**REHABILITATION OF THE SUROOR
ELEMENTARY SCHOOL
UNDER THE ECONOMIC SUPPORT FUND
HUSSEINIYA, IRAQ**

SUSTAINMENT ASSESSMENT

**SIGIR PA-08-135
APRIL 7, 2009**

SUBJECT: Report on Sustainment Assessment of the Rehabilitation of the Suroor
Elementary School, Husseinia, Iraq (SIGIR Report Number PA-08-135)

Figure 2. Architectural layout of the school after renovation (Courtesy of GRC)

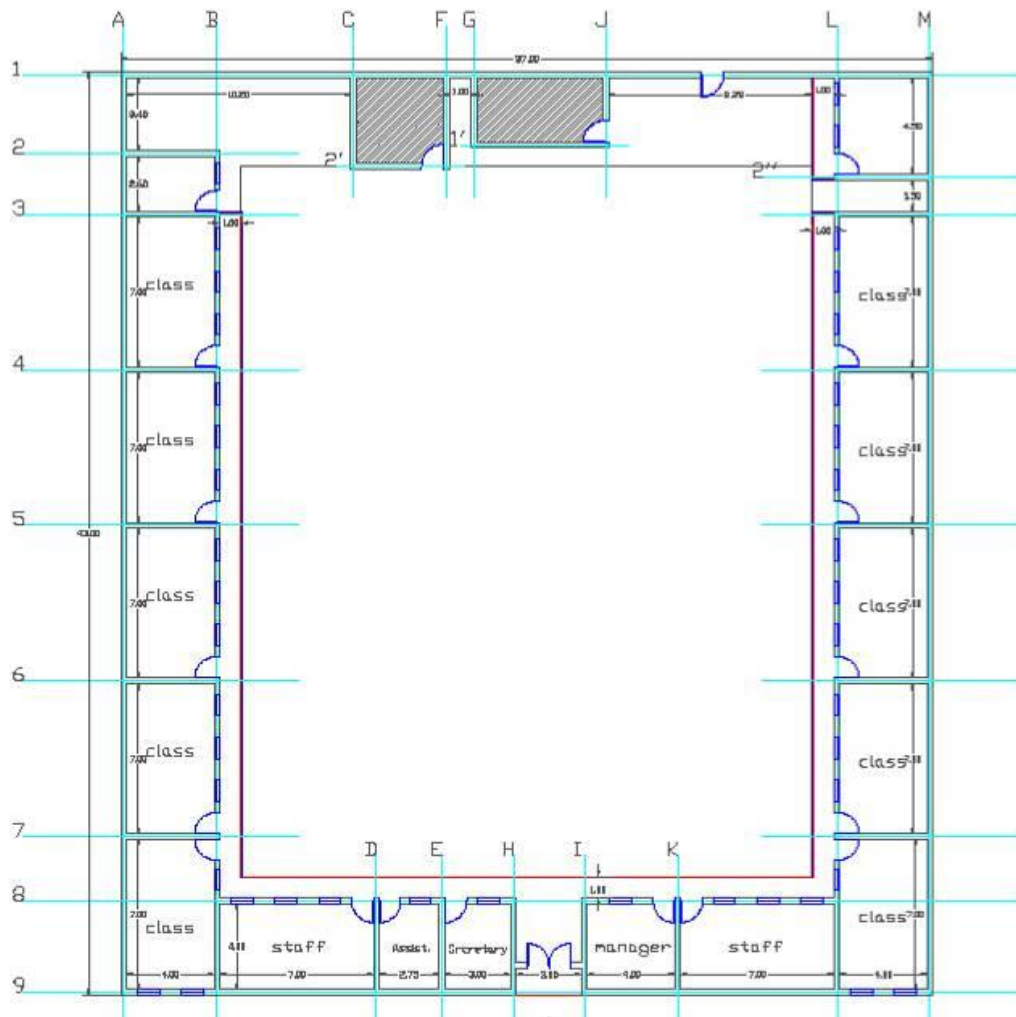
The architectural plans show the layout of 10 classrooms, 2 staff rooms, and administration areas (Figure 2). While the contractor's submittals included good details of the electrical distribution system, our review concluded that the design submittals did not appear adequate for the renovation project because of the omission of details such as elevations, plumbing, and storm drainage.

GRD disagreed and stated it was "appropriate for the contractor not to include storm drainage details in their submittal" since the SOW did not specifically address storm drainage or civil site work. However, this project included the replacement of colored tiles in the courtyard; therefore, civil site work designs were necessary and drainage for the courtyard needed to be addressed by the contractor in the design submittals.
